Gunstfontein Wind Energy Facility and associated infrastructure, Northern Cape Province

Motivation for amendment of Environmental Authorisation

DEA Ref.: 14/12/16/3/3/2/826

July 2019

Figure 2.1: Updated wind farm layout - A3 Map included in **Appendix H**.

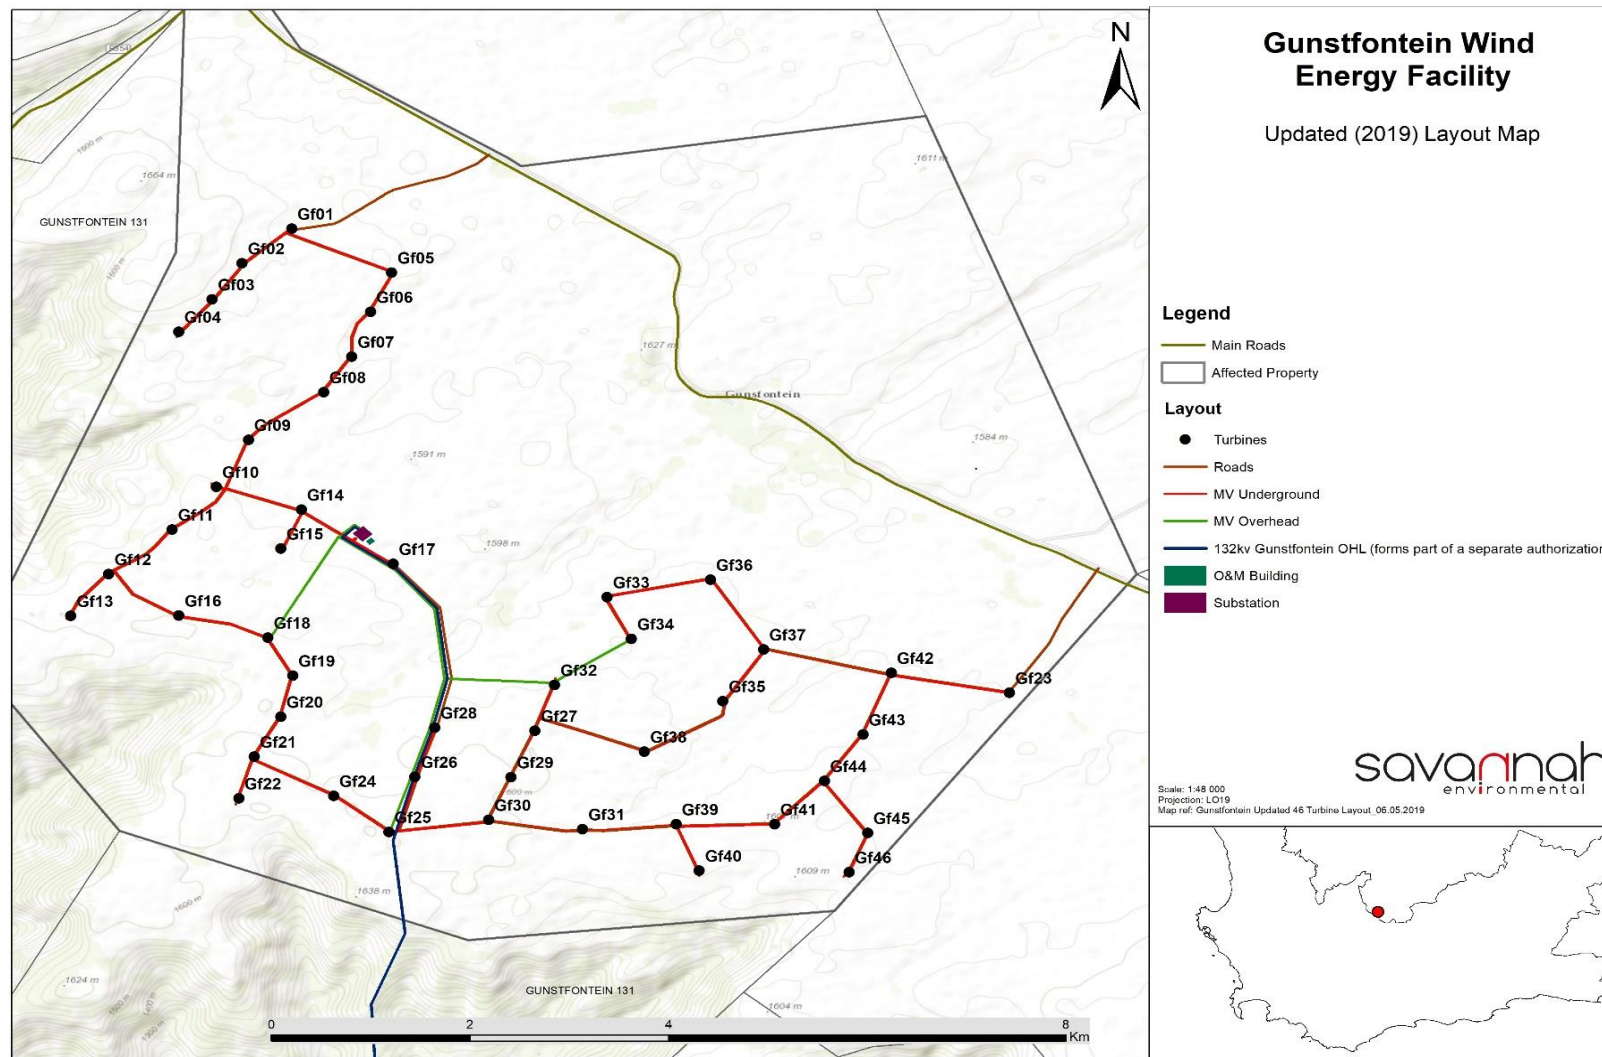
Component	Authorised specification	Amended specifications
Rotor diameter	140m	Range up to 180m
Hub height	120m	Range up to 150m
Site Access	Access to site: 32°32'12.91" S, 20°39'06.97" E	Site access point 1: 32°32'32.67" S, 20°39'40.95" E Site access point 2: 32°34'56.62" S, 20°42'59.77" E
Turbine Capacity	none	Up to 6.5MW

The proposed amended layout is presented in Figure 2.1. It must be noted that this layout will be finalised and submitted to the DEA for review and approval (in accordance with Condition 13 of the EA) once a turbine supplier has been selected for the project.

Figure 5.1: The revised 46 Turbine layout with avifaunal sensitivities and a 3km Verreaux's Eagle buffer.⁶

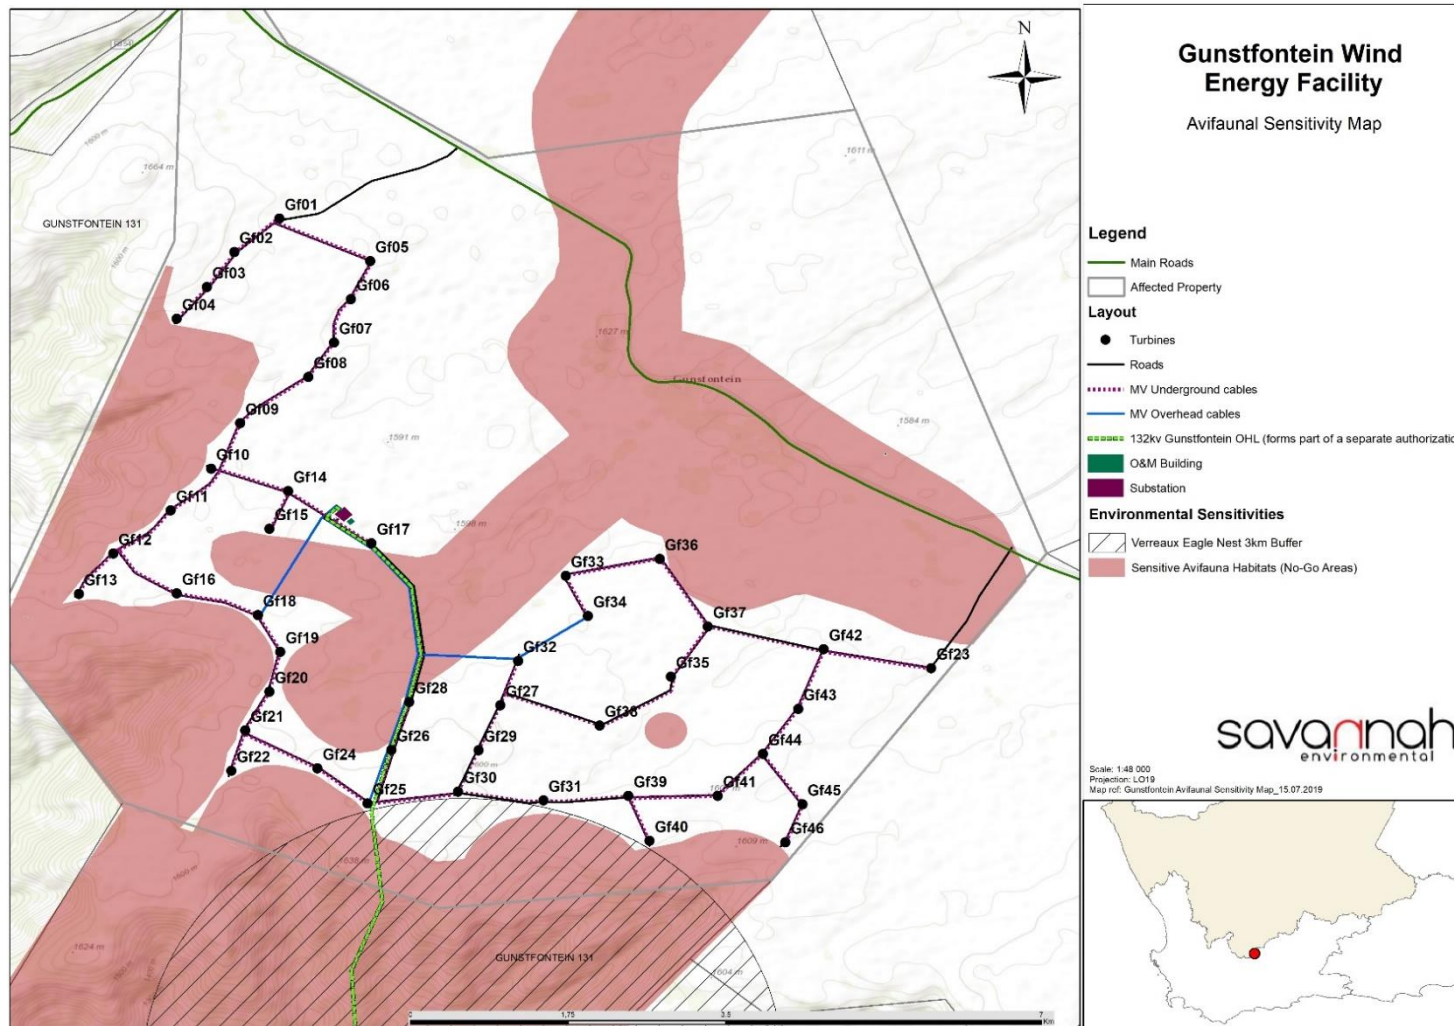
It was found that there is a change in the significance rating of the potential impact of wind turbine collisions from Medium to High without mitigation, and from low to medium with mitigation, for the following reasons:

It was found that the new layout adheres to the no-go areas given by BioInsight (2016). Therefore, this 'embedded design mitigation' was already considered in the 'Without Mitigation' rating. A provisional amended layout (shown in Figure 1 of the avifaunal report, Annexure C) was presented to the specialist for consideration, and the specialist noted that one turbine (Gf48) was situated within a no-go area, while 24 turbines (Gf04, Gf09-Gf13, Gf15, Gf16, Gf19-Gf28, Gf31, Gf33, Gf36, Gf37, Gf40 and Gf46) are situated on the boundary of the no-go area. The specialist recommended that Turbine Gf48 must be removed from the no-go area, while all turbines must be situated at least 70 m back from the no-go boundary in order to reduce the length of blade extending into the airspace above the no-go area. A 3 km No-go buffer should be placed around the Verreaux's Eagle nest site (NEGN03 in Appendix V of BioInsight, 2016) (Figure 5.1). All

Note that the amended (optimised) layout was adjusted in order to adhere to the specialist's recommendations stated above, and all turbines have been shifted outside of the avifaunal no-go buffer areas and have moreover been setback at least 70m away from the edge of the buffer to ensure no blade overhand into the buffer areas. In addition, a 3km buffer has been applied to the Verreux's Eagle nest. The updated amended layout was present to all specialists to consider, and is shown in Figure 5.1 and Appendix H of this report. New mitigation measures are underlined in the tables below.

Figure 5.3. Revised and refined sensitivity map of the Gunstfontein WEF site, depicting the amended layout of the facility. No parts of the development are within the no-go area.

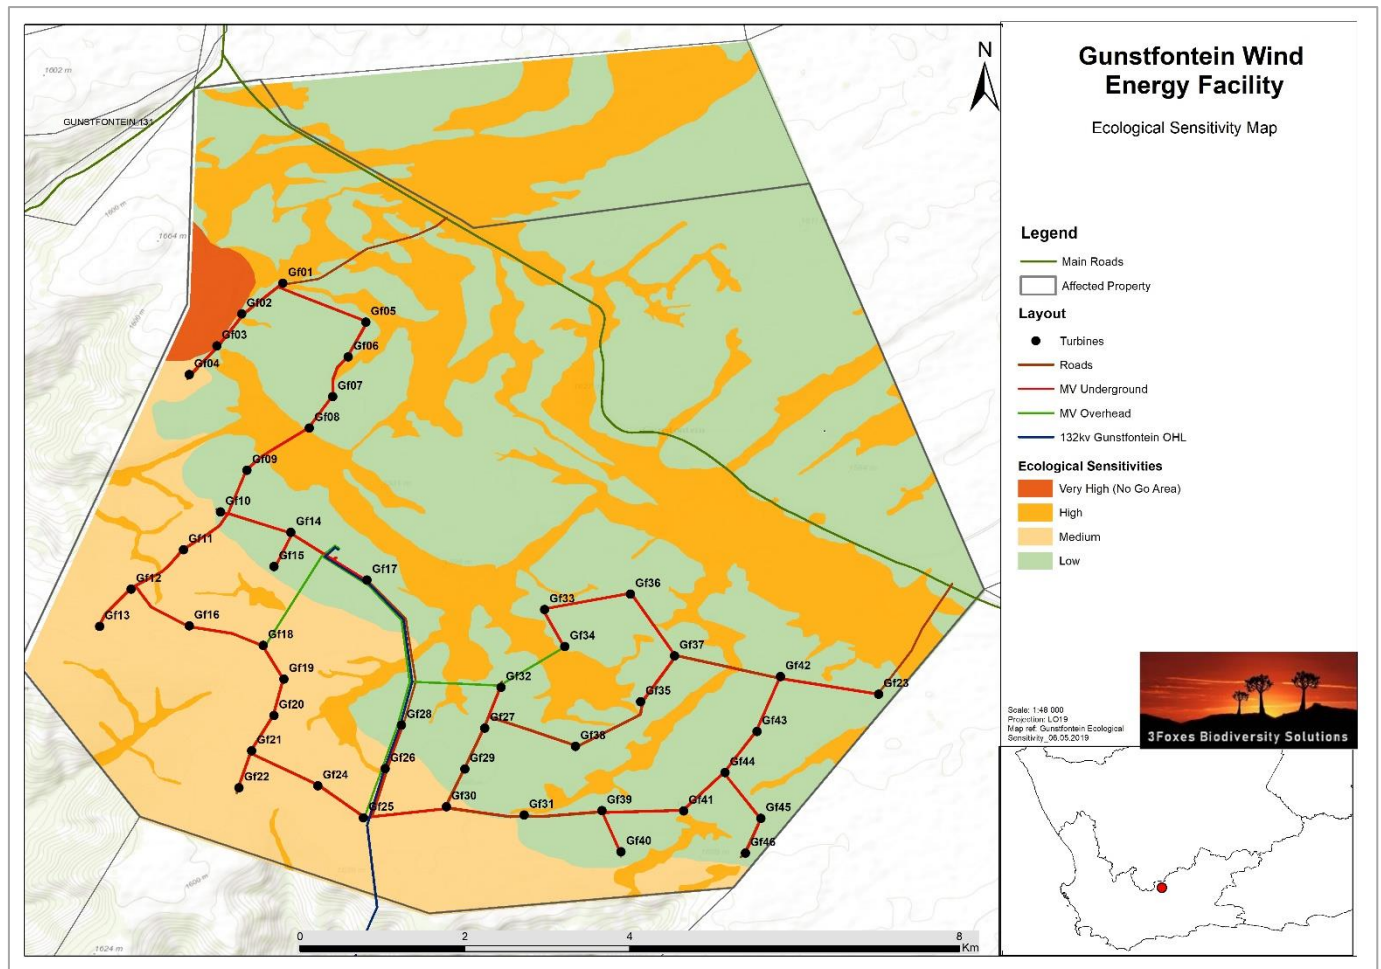
The revised layout for the amendment and the revised sensitivity mapping as produced for the amendment is provided in Figure 5.3. The revised sensitivity mapping is based on the original ecological study by Todd (2016), the review and field assessment of MacDonald (2017), as well as the specific field assessment that was conducted for the current assessment on the 16th of January 2019 by Todd. During the field assessment for the current study, those areas that had previously been identified as high or very high sensitivity¹⁰ were checked and where necessary refined in the field and specific note was taken of the presence of species or habitats of conservation concern in these areas. Where appropriate, the sensitivity of these areas was adjusted upwards, downwards or kept the same as necessary. This information was provided to the developer in the form of the revised sensitivity map, which was then used to inform the layout for the amendment. In addition to the sensitivity mapping, to ensure that the impacts associated with the project remain within acceptable bounds, limits of acceptable change associated with each sensitivity class were provided to the developer. This provides a guide for the developer in terms of ensuring that the spatial distribution of impact associated with the final layout is appropriate with respect to the sensitivity of the site. In addition, it provides a benchmark against which impacts can be assessed and represents an explicit threshold that when exceeded indicates that potentially unacceptable impacts may have occurred. The

updated (including revised turbine positions and additional access road)¹¹ turbine layout is presented below in Figure 5.3, along with the revised sensitivity assessment. The limits of acceptable change provided to the developer are listed in Table 5.3.1.

The final development footprint in relation to the above limits of change are listed below in Table 5.3.2. The extent of the development within each sensitivity class is well-within the specified limits of acceptable change and as such, there are no fatal flaws associated with the amended layout. As there are also no turbines or other development features within the mapped no-go areas, no specific recommendations are made with regards to relocating any of the turbines or other features of the layout. As such, the final layout as provided for the amendment is considered acceptable with regards to the identified sensitive features and general sensitivity mapping at the site.

Figure 7: Comparative Viewshed Analysis – Gunstfontein Wind Energy Facility.

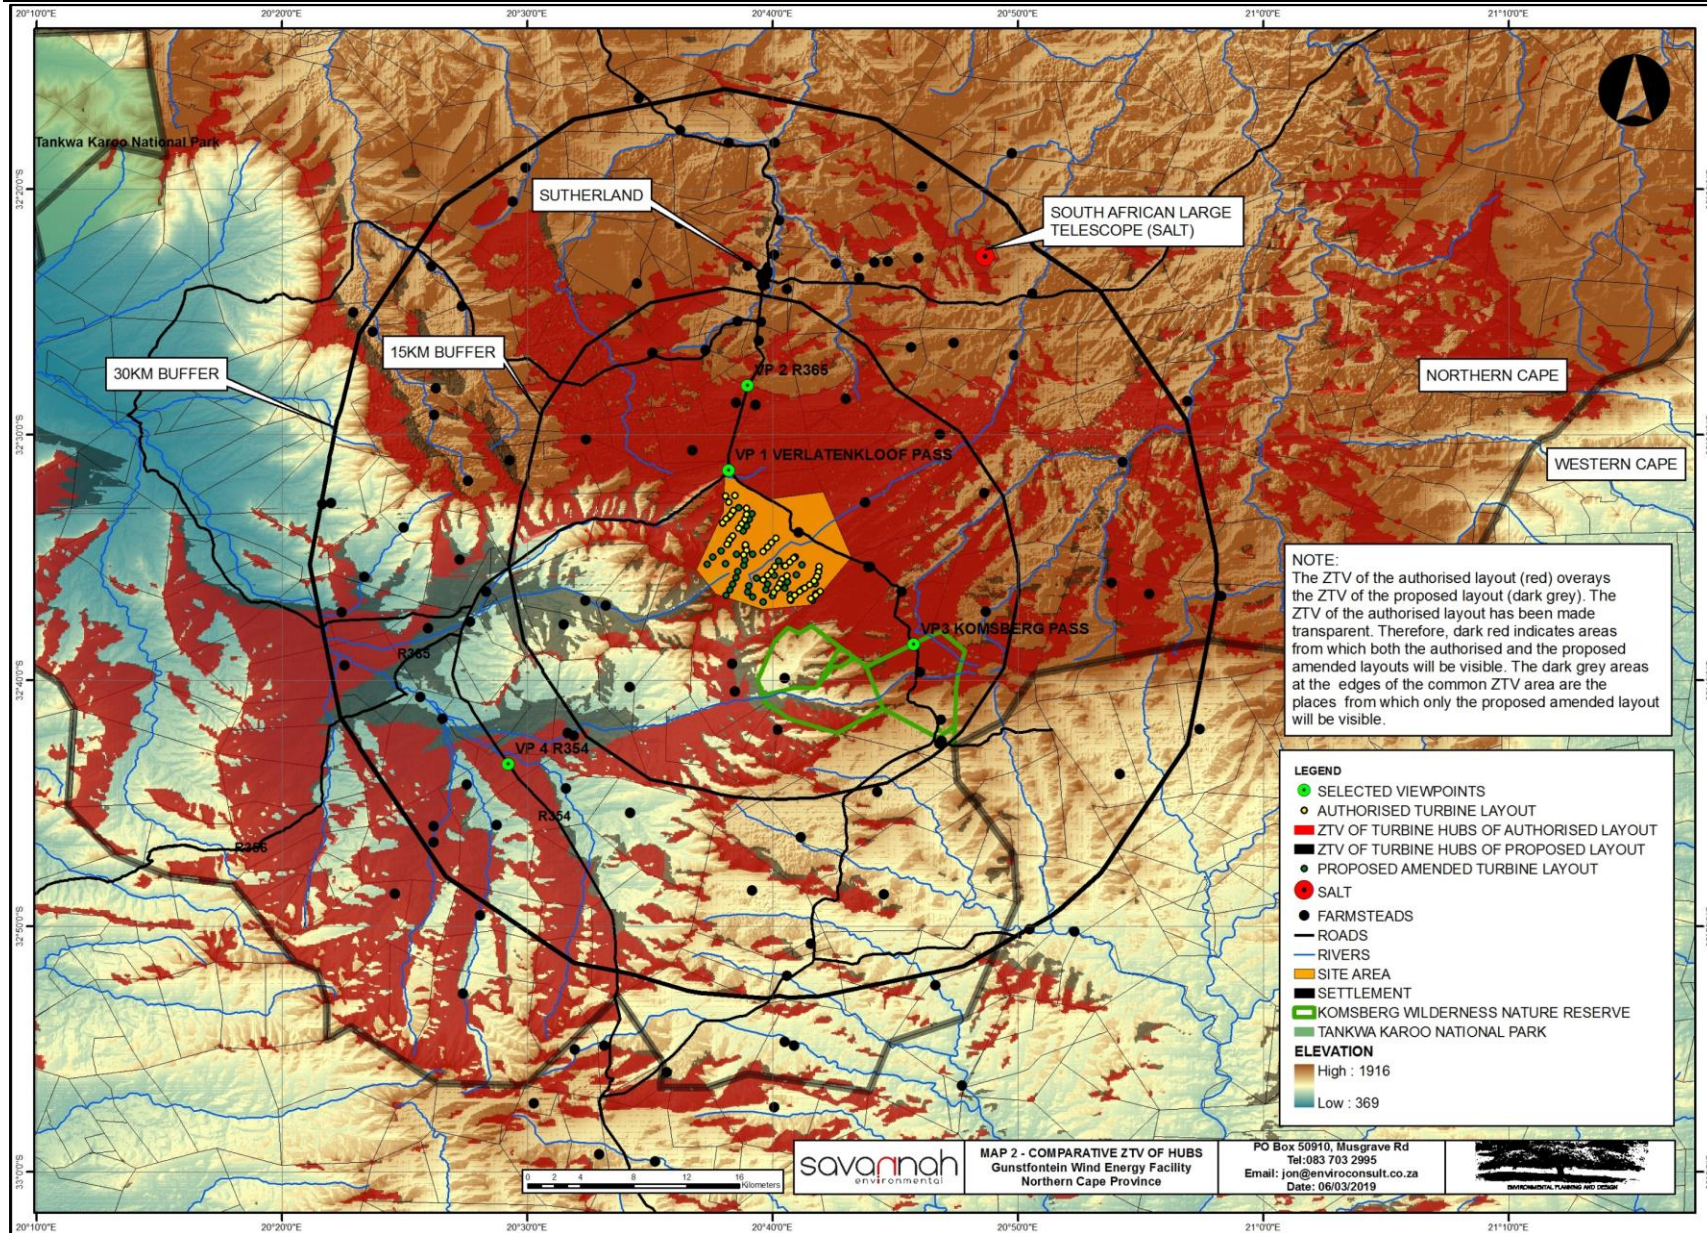
- » **VP1 (Figure 5.7) Verlatenkloof Pass:** The turbine structures used in the proposed amended layout are approximately 25% taller than those proposed in the authorised layout, due to the fact that the closest structure is approximately 2.9km (proposed amended layout) from the viewpoint as opposed to 1.9km (authorised layout), the apparent height of the structures due to this increased difference is noticeably lower. This indicates that the proposed development layout is likely to result in a reduced visual impact from the top of Verlatenkloof Pass and the closest sections of the R354 when compared with the authorised layout.

- » **VP2 (Figure 5.7) the R354:** This is one of two main routes into and out of the town of Sutherland and is approximately 6.5km to the north of the project site. The additional height associated with the proposed amended layout is not highly obvious when compared with the authorised project. Visual impact on this section of road is therefore not likely to increase to any significant degree therefore.

- » **VP3 (Figure 5.7) un-surfaced road that runs down the Komsberg Pass:** This road is 7.2km to the east south of the site. The additional height associated with the proposed amended layout is not highly obvious when compared with the authorised project and the proposed amended layout does extend over a marginally wider section of the landscape when compared with the Authorised Layout. From this area therefore the proposed project is likely to have a marginally greater level of visual impact.

- » **VP4 (Figure 5.7) this viewpoint is approximately 18.5km to the south west on the R354 and within the Buffels River Valley.** From this viewpoint the additional height of structures is not highly obvious. It is obvious that the proposed amended layout will result in a greater number of turbine structures visible when compared with the authorised layout. This is likely to be largely due to the proposed amended layout resulting in turbines being located approximately 3km closer to the edge of the Komsberg ridgeline when compared with the authorised layout.

From review of Figure 5.7 which indicate the approximate number of turbines that are likely to be visible from each area, it appears that approximately 9 – 10 proposed turbine locations are responsible for creating this additional impact. The possible relocation of turbines in order to minimise this additional impact has been discussed with the Applicant. However, it has been confirmed that because the larger turbines require more space between them to reduce internal wake effects they have to be spread across the previously assessed footprint.

Figure 5.6: New locations of wind turbines compared with old layout.

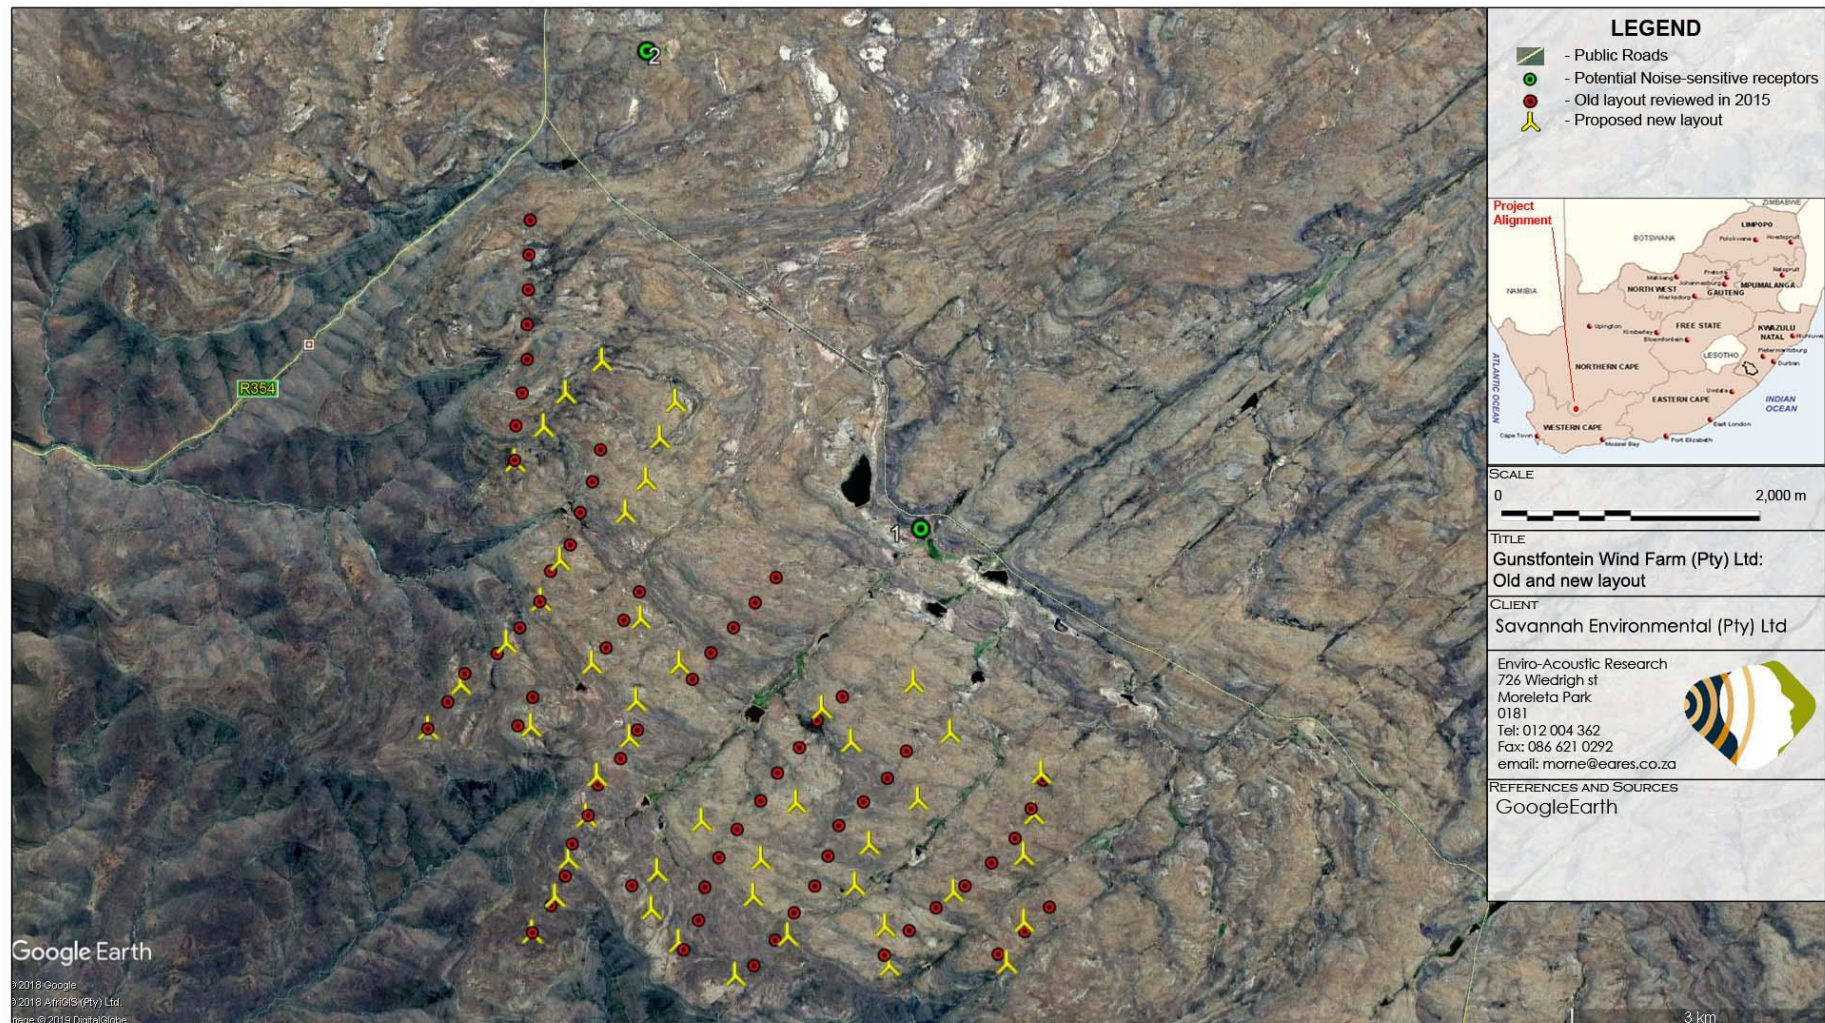
An optimized layout is proposed for the Gunstfontein Wind Farm, designing the wind turbines at optimal locations (see Figure 5.8). The change however does not move any wind turbines closer than 1 000 m from any potential noise sensitive developments (NSDs), with the closest wind turbine located more than 1 700 m from the closest NSD. Considering the location of the wind turbines and the potential noise impact, it is the opinion of the specialist that the change will not increase the significance of the noise impact.
